PL202200038
PL2022-38

Sheet Title: Plans

Project:
La Cuatro Milpas
431 E 78th St
Bloomington, MN 55420

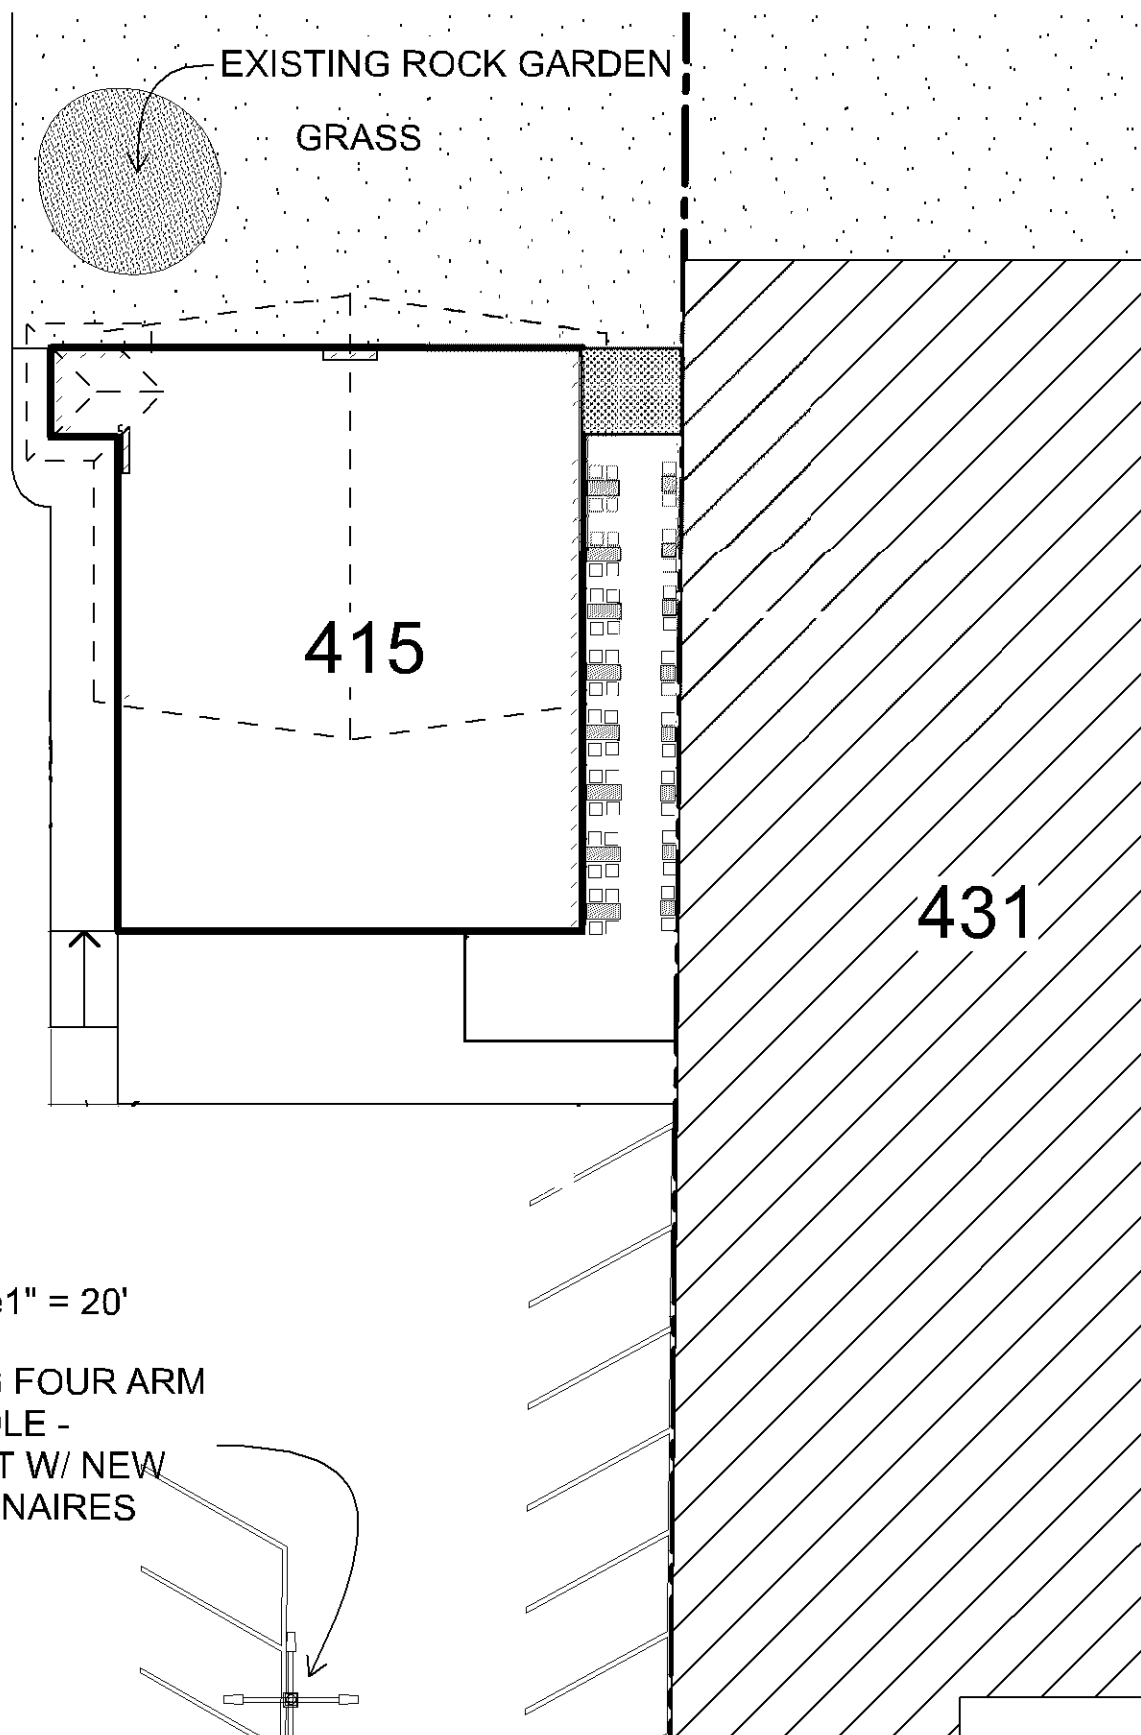
Current State plans show E 78th St eliminated from 5th Ave to Portland Ave.

Platting required. See platting comments.

It is desired parking lot should have some separation from the sidewalk along 5th Avenue.

Boulevard area in red must be restored.

A101

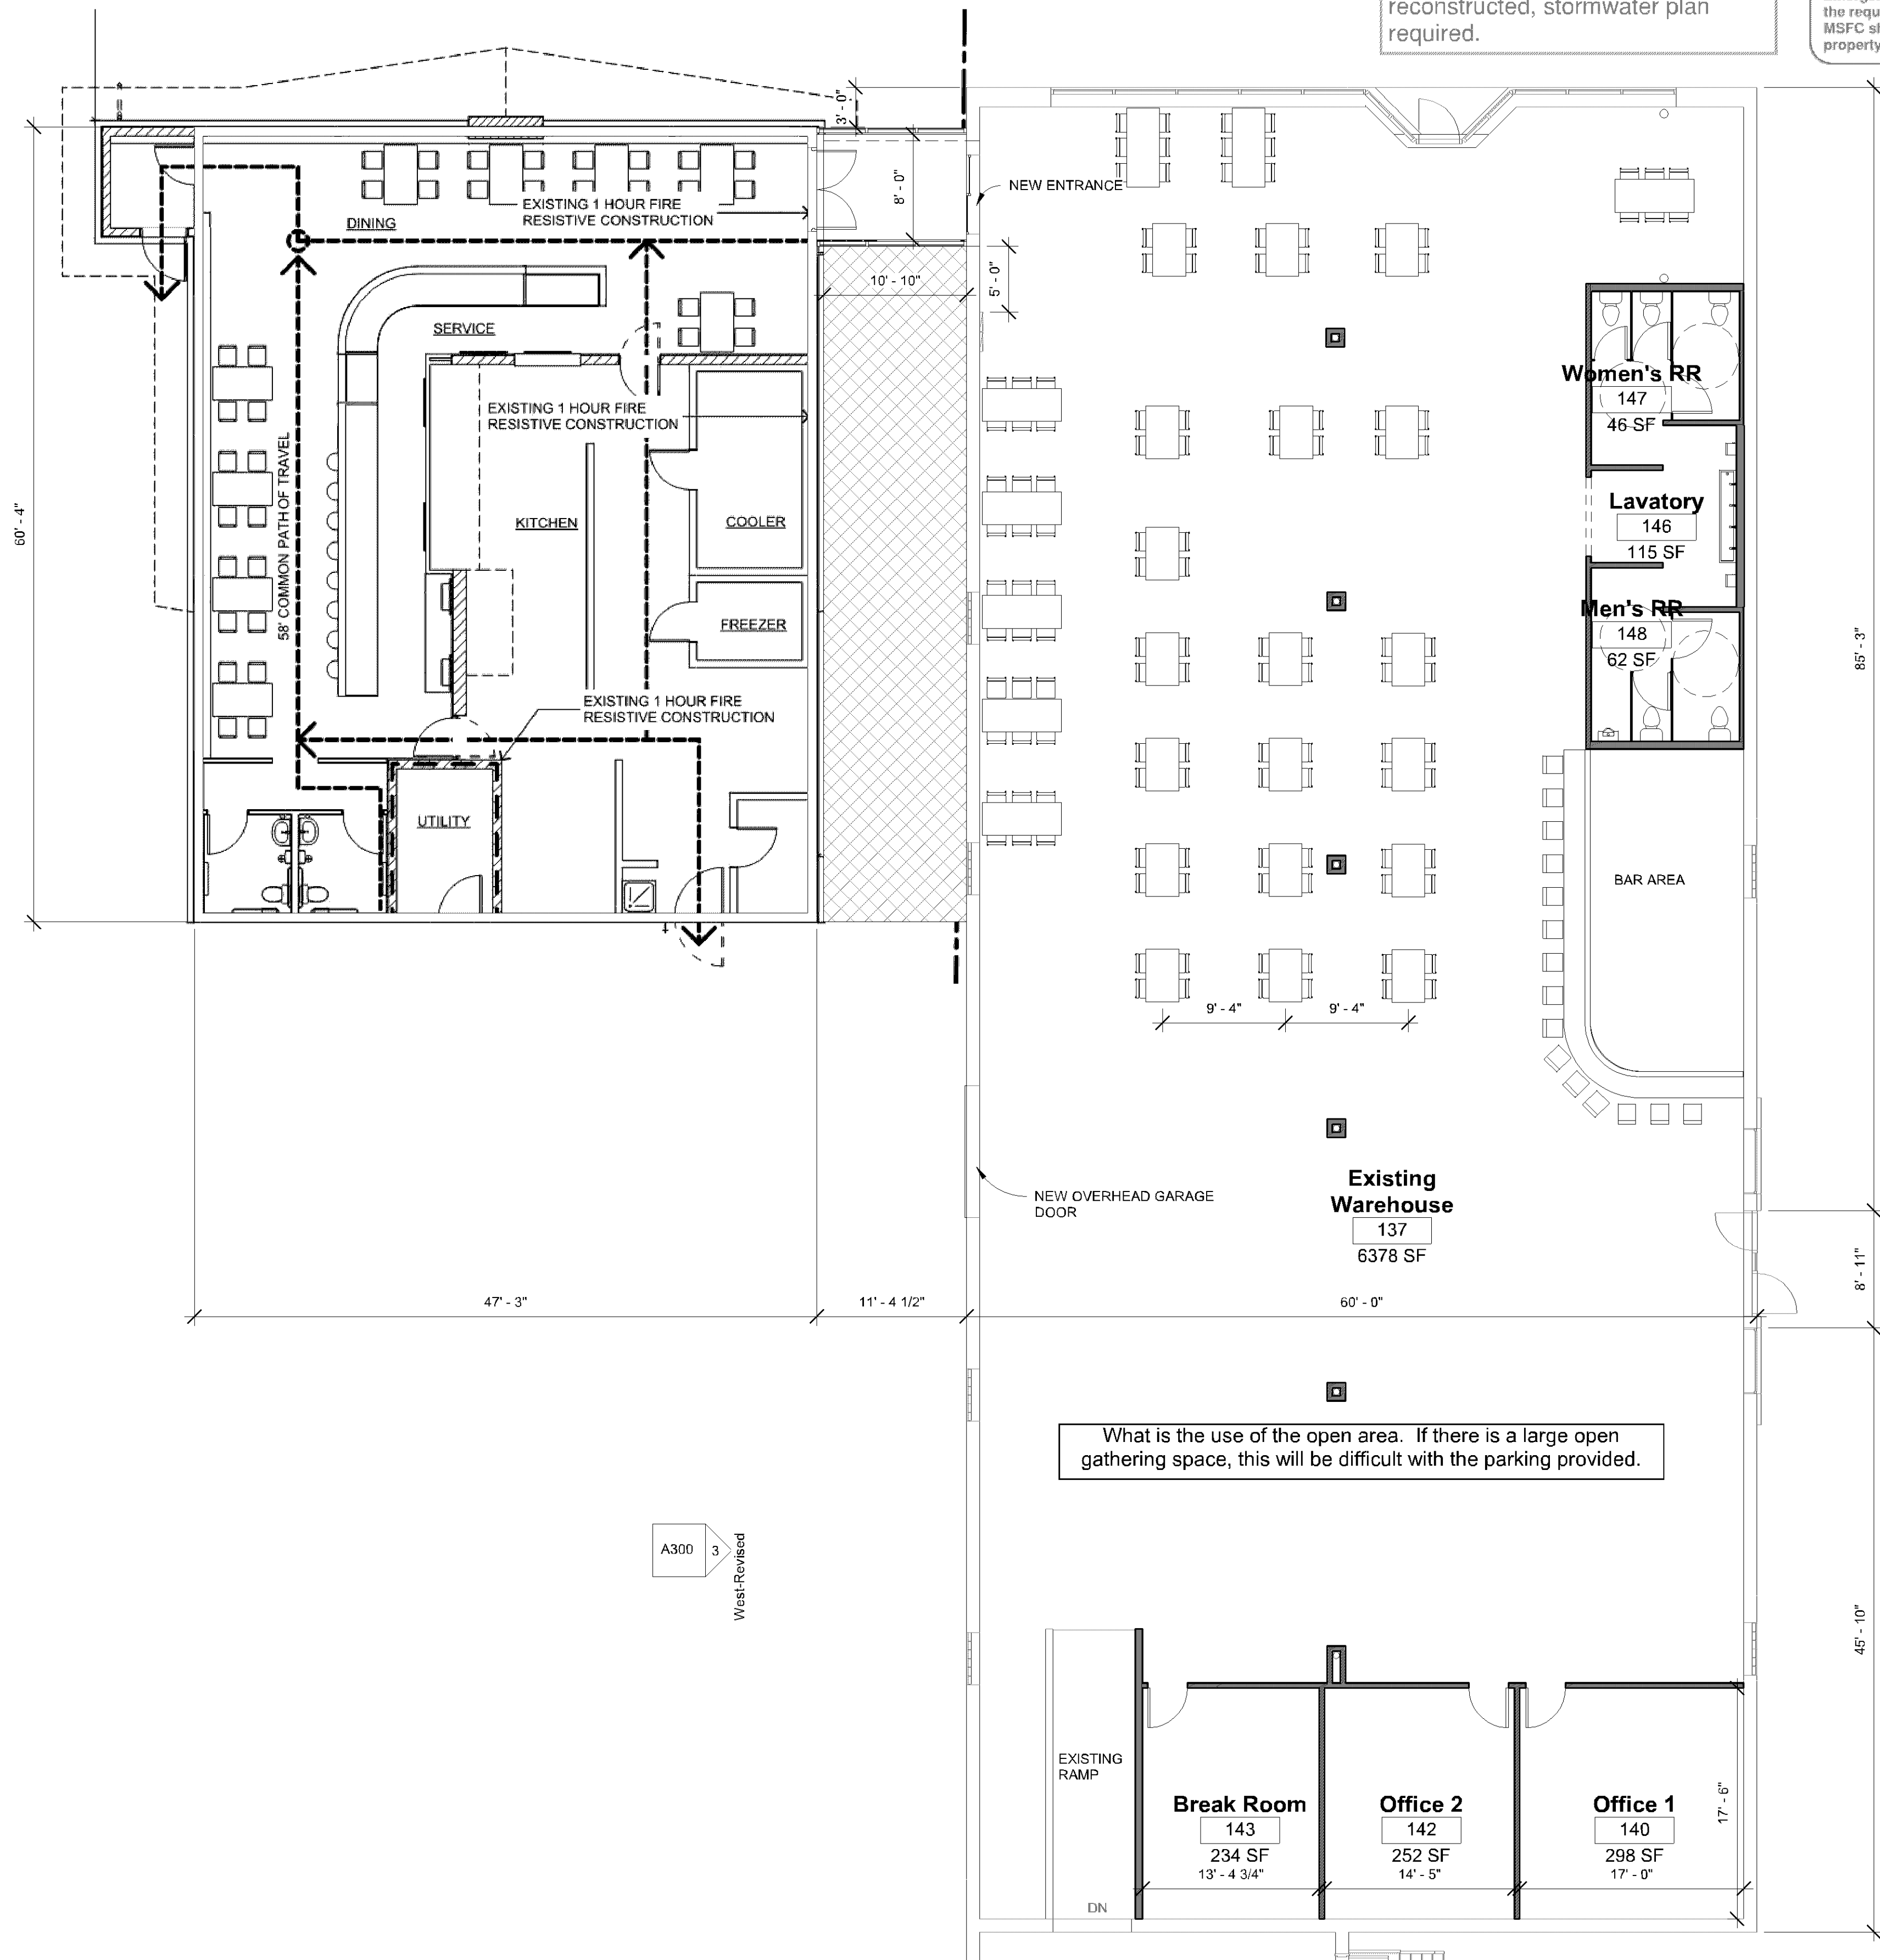
Erosion control plan required.

If more than 5,000 SF of area is reconstructed, stormwater plan required.

Entire space(s) must have fully Code complying sprinkler protection.

Building property shall be adequately signed for emergency response.

Emergency responder radio coverage meeting the requirements of appendix L in the 2015 MSFC shall be provided throughout the property and within the structures.

Must meet 2020 MN State Building Code

Must meet 2020 MN Accessibility Code.

SAC review by MET council will be required.

Building plans must be signed by a MN licensed architect.

Provide a detailed code analysis with the plans.

Fire alarm system will need to be upgraded in the new building for the new occupancy.

Any additions or changes to food service must be approved by the Health Department prior to construction if required.

Maintain emergency vehicle access and circulation throughout the properties.

What is the combined area of both buildings? Is this going to be re-platted or are these going to be separate lots?

Provide an Environmental Health Plan Review application with plan submittal for each proposed food facility.

Appliances/cooking producing grease laden vapors requires a hood and suppression system.
